## Rampion 2 windfarm proposal EN010117

Janine Creaye IP no 20045132

### Our June assessment of Talbot & Baker II site at Crateman's Farm Cowfold

Tree Boundary/Green Lane between Moatfield Lane and Wilcocks Farm on Kent Street, marked for tree loss

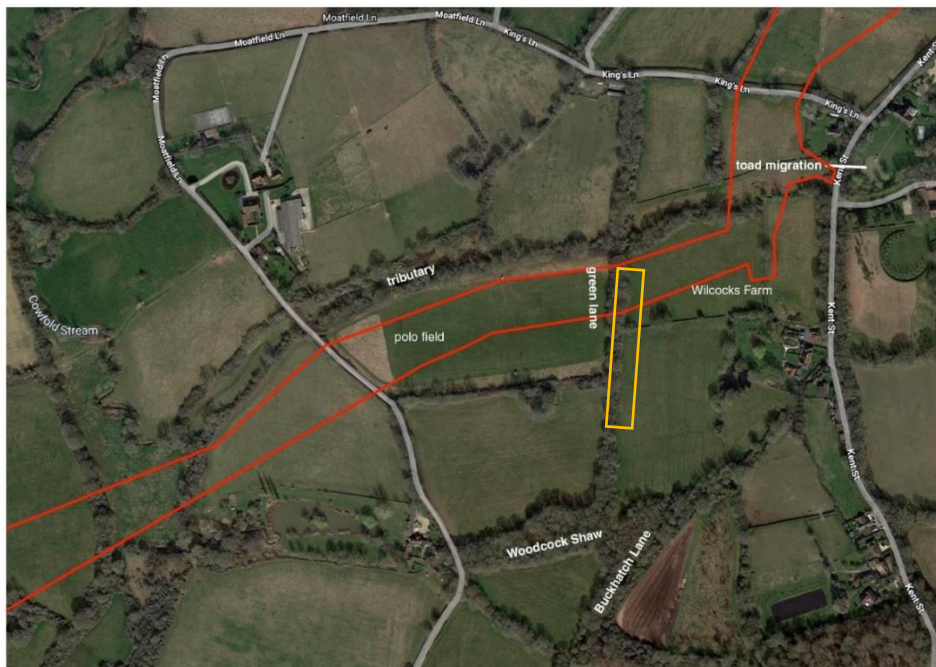
I am writing in response to the concerns raised about the proposed removal of trees and habitat at 'Green Lane' to facilitate the construction of infrastructure for the Rampion wind farm project, namely a 6m wide service road and associated cable trenching, which will result in up to 14 metres of this area being removed.

Green lane comprises historic field boundary mature English oak with native understorey including field maple, hawthorn, blackthorn and hornbeam. The mature oak element includes veteran trees that are exhibiting numerous ecological and habitat features, including decay pockets, dysfunctional wood and larger diameter dead wood, all of which significantly increase the ecological importance of these trees.

The oak trees within the Green Lane area have been surveyed as part of the arboricultural impact assessment for the Rampion project and are grouped as G35 within that report, these trees have been classified under British Standard 5837: Trees in Relation to Design, Demolition and Construction as category 'A' trees, a classification that assigns a high level of arboricultural value. A full assessment of the ecological importance of these trees does not seem to have been included as part of the arboricultural assessment for the site.

Therefore, it is my professional opinion that the overall impact of the removal of these trees to facilitate the proposed development especially regarding their ecological value has not been fully explored.

The smaller native understorey trees within the Green Lane area provide a stratified and structurally diverse field edge habitat as well as providing a valuable continuous habitat link between both the mature oak trees within Green Lane and the wider countryside landscape, including the tributary to the north and Woodcock Shaw to the south. These links would be significantly compromised if not completely severed if the proposed tree removals take place.

Green Lane is a historic field boundary shaw feature with map evidence dating back to 1843-1892 and is likely to have been a part of the local farmed landscape for centuries. Green Lane includes a defined bank and ditch feature that indicates potential historic significance that should be further explored before elements are removed to facilitate the proposed development and its historic significance is destroyed forever.

It is my professional opinion that the arboricultural, ecological and historic importance of Green Lane has not been fully explored as part of the proposed Rampion Windfarm development. Should removal of sections of Green Lane take place to facilitate development it is my concern that this valuable and irreplaceable habitat feature will be significantly degraded and accordingly the arboricultural, ecological and historic value of Green Lane will be totally compromised.
